R22

SERVICE BULLETIN SB-97

SUBJECT: Pedal Support Safety Tabs

ROTORCRAFT AFFECTED: R22 Helicopters S/N 0002 thru 3325 with more than 2200 hours total time in service.

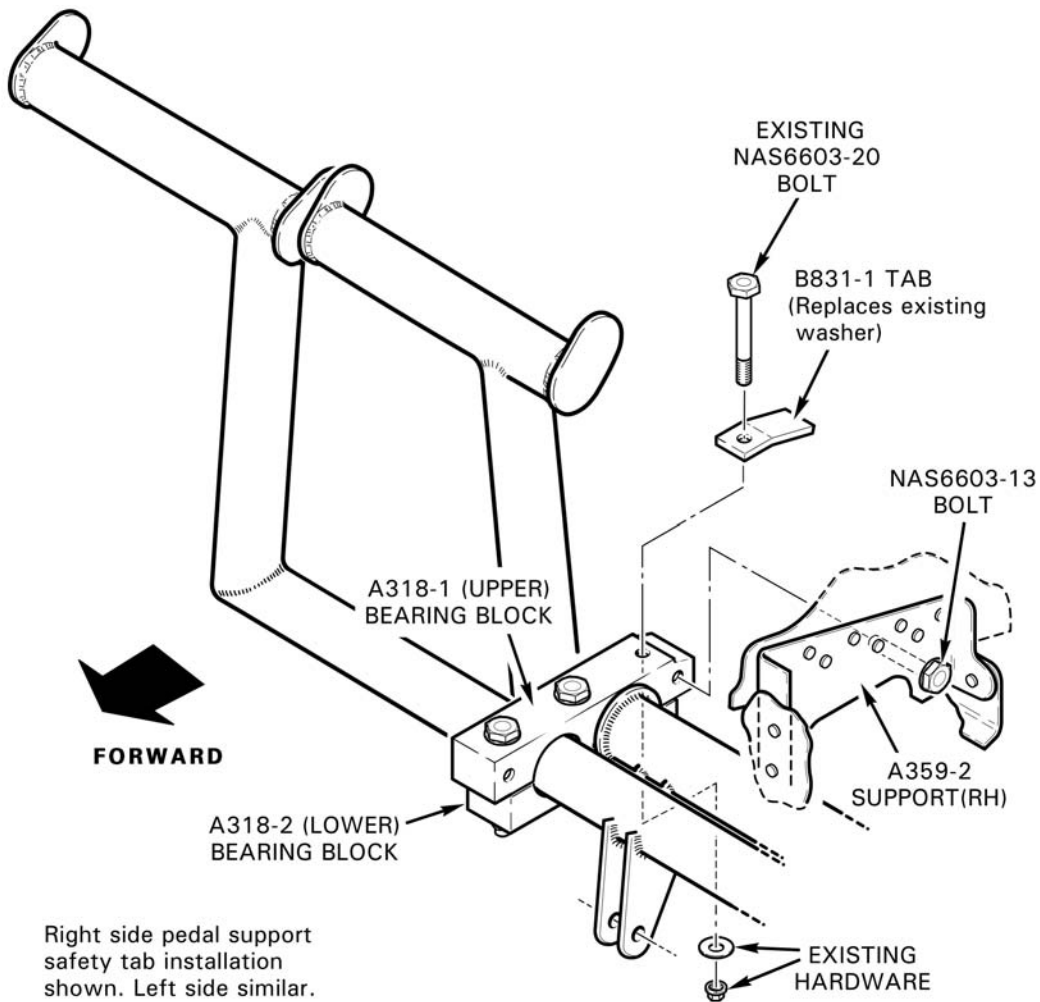
BACKGROUND: RHC has received reports of early-revision 0.040-inch thick A359-1 & -2 pedal bearing block supports cracking on aircraft with more than 7000 hours time in service. Later-revision supports are thicker. If helicopter has more than 2200 hours time in service and 0.040-inch thick supports are installed, this Service Bulletin requires installing safety tabs to prevent possible tail rotor control binding if a support fails.

1. Refer to figure on page 2. Open instrument console to access left A359-1 and right A359-2 supports. Visually inspect both supports and verify no cracks. Pay particular attention to area near NAS6603-13 bolts. Replace any cracked support before further flight.

2. Measure thickness of both supports. If either support is 0.040-inch thick, proceed to step 3. If both supports are at least 0.050-inch thick, no further action is required. Close and secure instrument console.

4. Dampen carpet adhesive between left-seat and right-seat pedals with Dupont Prep-Sol (or equivalent) to facilitate removal. Gently peel back carpeting and remove covers between pedals. Remove aft-vertical NAS6603-20 bolt and corresponding hardware from left and right bearing blocks and discard one accompanying washer per side.

5. Install a B831-1 tab under head of both NAS6603-20 bolts per figure on page 2. Torque both bolts at head to 55 in.-lb and torque stripe.
